# UNITED STATES PATENT AND TRADEMARK OFFICE

APPLICATION NO.	FILING DATE	FIRST NAMED INVENTOR	ATTORNEY DOCKET NO.	CONFIRMATION NO.
10/619,837	07/14/2003	Gregory Pinchasik	4303-4003US6	7636
7590 04/29/2009				
DOROTHY R. AUTH				
CADWALADER, WICKERSHAM & TAFT LLP				
ONE WORLD FINANCIAL CENTER				
NEW YORK, NY 10281				
EXAMINER				
BUL VY Q				
ART UNIT		PAPER NUMBER		
3773				
MAIL DATE		DELIVERY MODE		
04/29/2009		PAPER

### Office Action Summary

## DETAILED ACTION

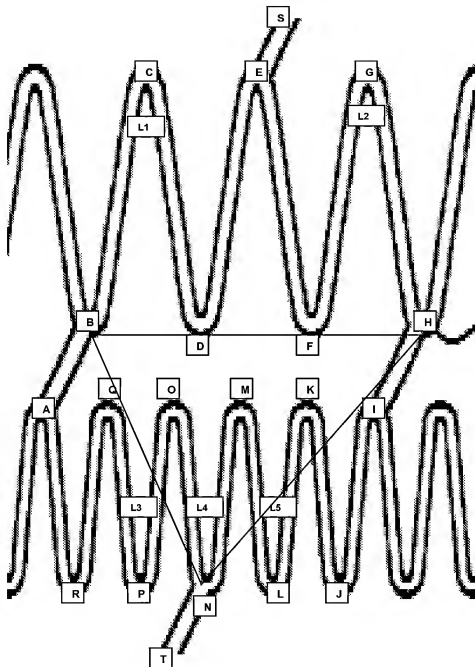
As to claims 95-103, 125-138, 140-145, 147-148 and 184-188, Brown-'848's Fig. 2 and Fig. 3 show a stent of stainless steel or Nitinol (C. 12, ll. 25-37 and enlarged one cell below) including triangular cells having wider and stronger members of lower frequency F1 (1<sup>st</sup> member ABC, 2<sup>nd</sup> member CDE, 3<sup>rd</sup> member EFG, 4<sup>th</sup> member GHI) than members of higher frequency F2 (5<sup>th</sup> member ARQP, 6<sup>th</sup> member PO, 7<sup>th</sup> member ON, 8<sup>th</sup> member NM, 9<sup>th</sup> member ML and

10<sup>th</sup> member LKJI) and 1<sup>st</sup> to 10<sup>th</sup> members formed 1<sup>st</sup> loop L1, 2<sup>nd</sup> loop L2, 3<sup>rd</sup> loop L3, 4<sup>th</sup> loop L4 and 5<sup>th</sup> loop L5 substantially as recited in the claims.

As to claims 128-129, 1<sup>st</sup> member ABC is about twice 6<sup>th</sup> member PO.

As to claim 130, 2<sup>nd</sup> member CDE is about the length of 5<sup>th</sup> member ARQP.

As to claim 133, 1<sup>st</sup> member ABC is wider than 5<sup>th</sup> member ARQP.

As to claim 134, longest 2<sup>nd</sup> member CDE (joined 3<sup>rd</sup> member EFG) extends from E to S in the adjacent cell.

As to claims 141 and 143, portion AB of 1<sup>st</sup> member ABC is more rigid than portion OP of 6<sup>th</sup> member OP.

*Fig. 30*

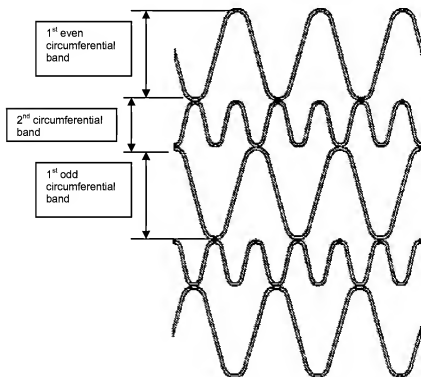
2. Claim 195 is rejected under 35 U.S.C. 102(e) as being anticipated by Jayaraman-6,162,245.

As to claim 195, Jayaraman-'245's Fig. 28 and Fig. 30 (see below) show a stent including 1<sup>st</sup> circumferential bands of lower frequency F1 and circumferential bands of higher frequency F2 substantially as recited in the claims.
